RFQ NUMBER
DEFK6238

LINE	QUANTITY	UOP	CAT. NO.	ITEM NUMBER	UNIT PRICE	AMOUNT
	*****			ADDENDUM NO. 1	*****	
	ADDENDUM ISSUED TO DISTRIBUTE THE PRE-BID INFORMATION FOR THE WILLIAMSTOWN AASF TAXIWAY EXPANSION PROJECT. ENCLOSED IS THE PRE-BID SIGN-IN SHEET, THE MEETING MINUTES, MEETING QUESTIONS & ANSWERS, CONTRACT DOCUMENT REVISIONS, BIDDING REQUIREMENT REVISIONS, SPECIFICATION REVISIONS, TEST BORING LOGS, AND A TEST PIT LOCATION DRAWING PROVIDED FOR REFERENCE ONLY. THE BID DATE AND OPENING TIME REMAIN UNCHANGED FOR THIS PROJECT. BID DATE IS 08/10/06 OPENING AT 1:30 PM. ***** NO OTHER CHANGES *****

WILLIAMSTOWN APRON EXPANSION & REHABILITATION
AASF #1
WILLIAMSTOWN, WV

**AASF #1 APRON EXPANSION / REHABILITATION
AND TAXIWAY REPLACEMENT
CONTRACT DOCUMENT REVISIONS**

DEFK6238
TEST PIT LOCATIONS
Williamstown Apron Expansion & Rehabilitation
AASF #1
Williamstown, WV

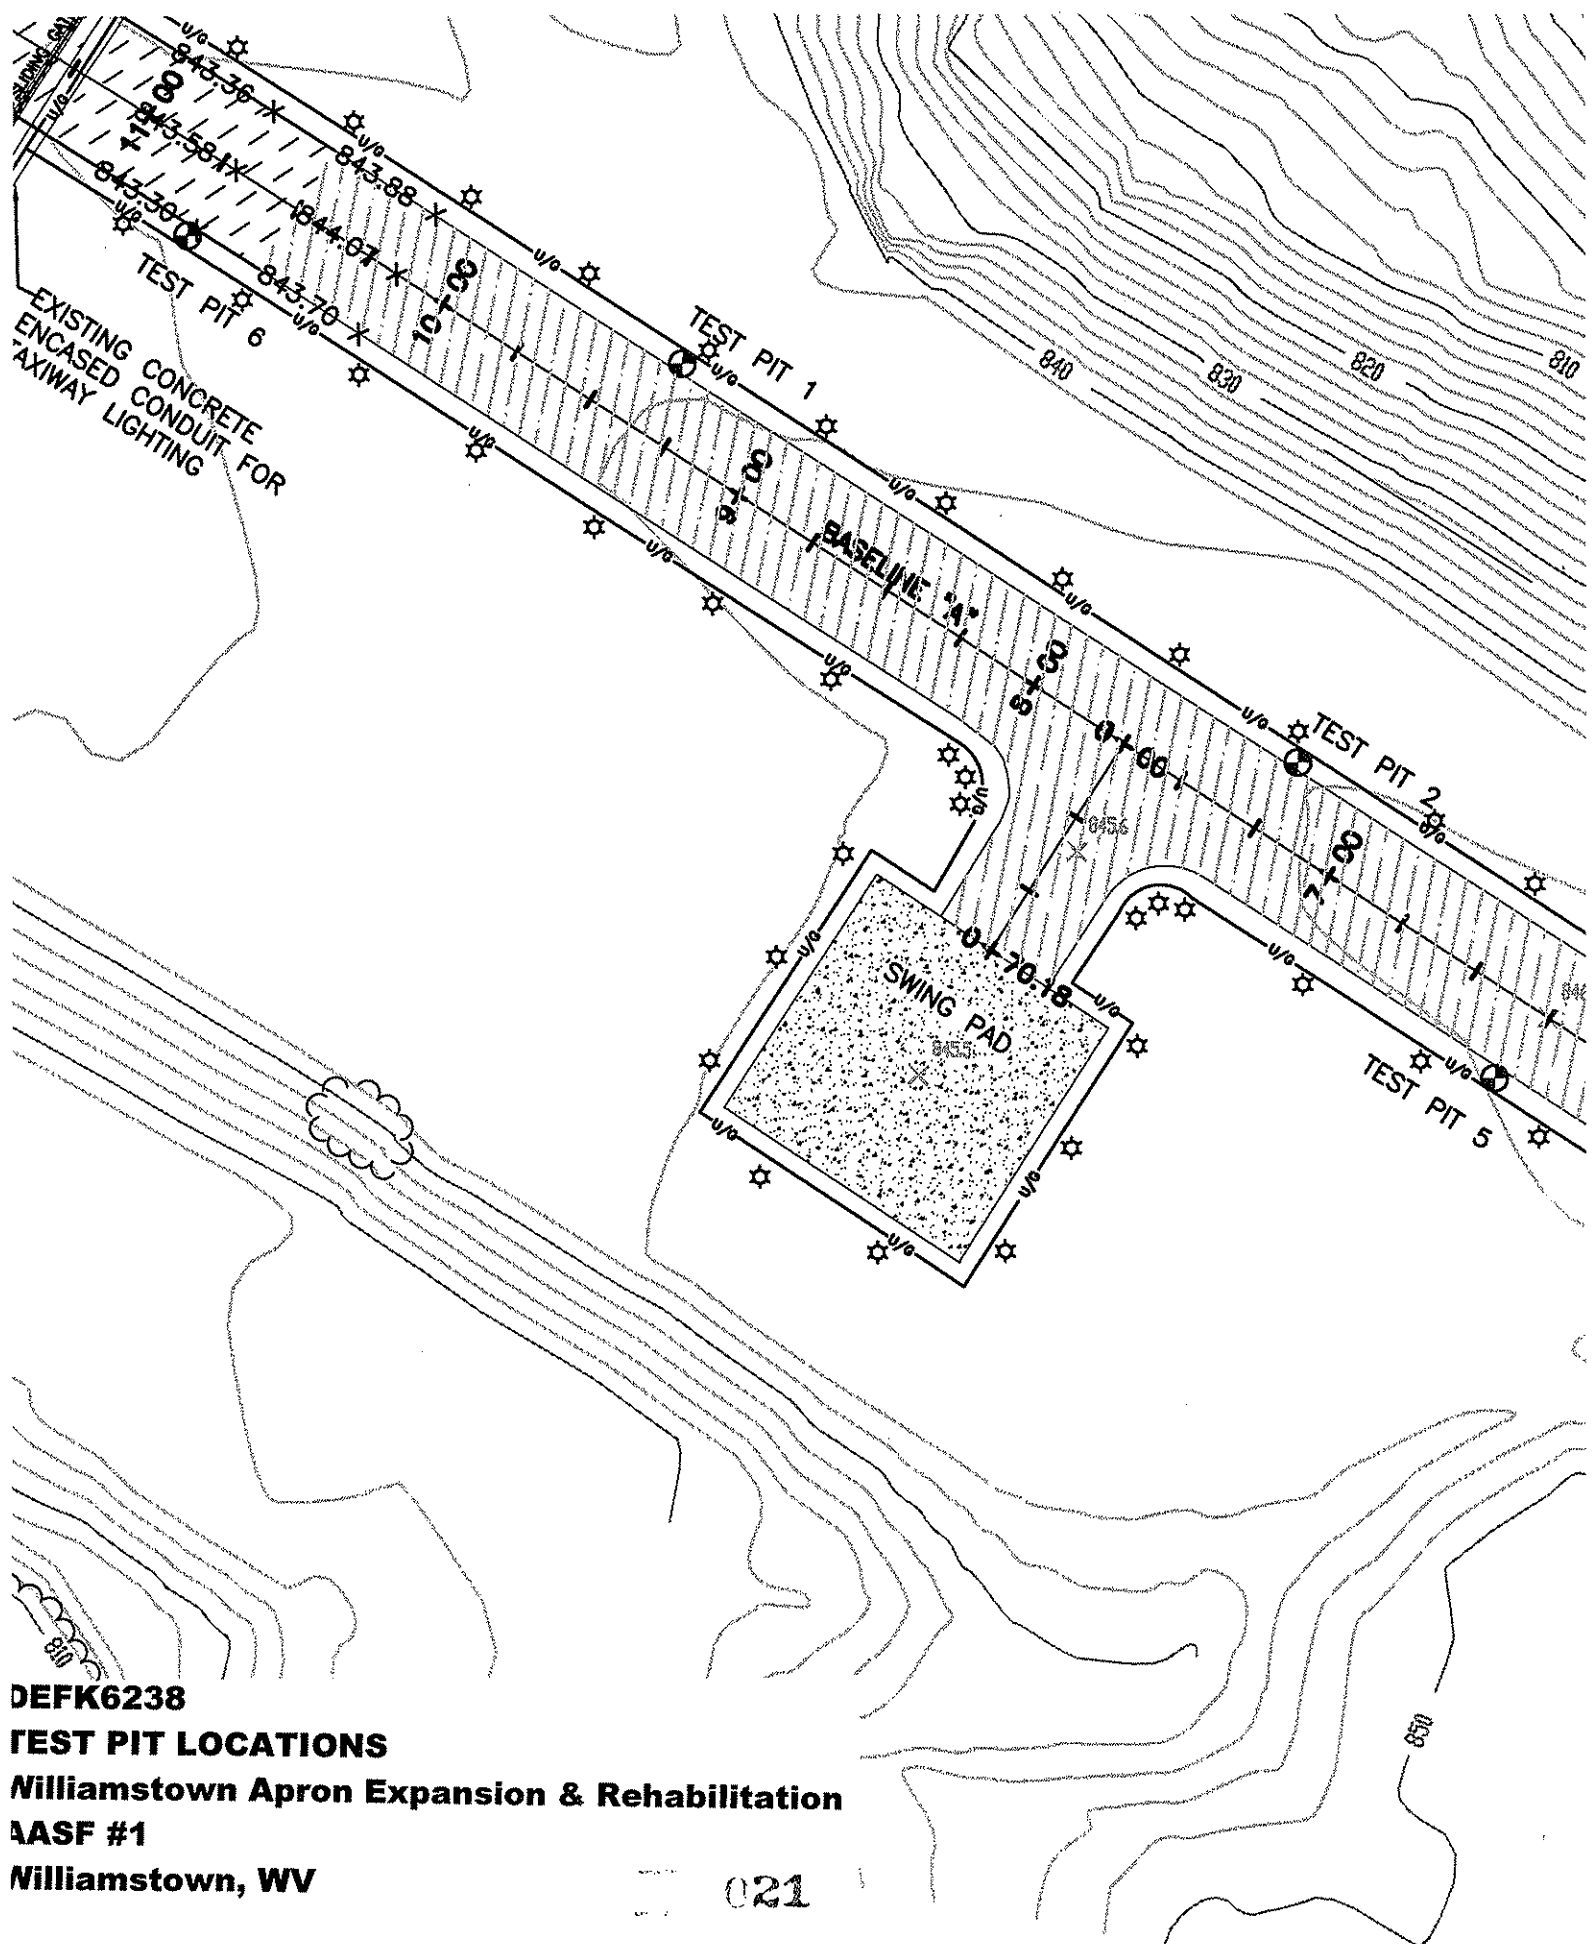
For clarification, unsuitable materials are defined in the specifications (including organic material). Material that has gotten too wet is NOT unsatisfactory due to this and is required to be dried before placement as per contract documents. Test pit data has been included as Attachment #2 as part of this package.
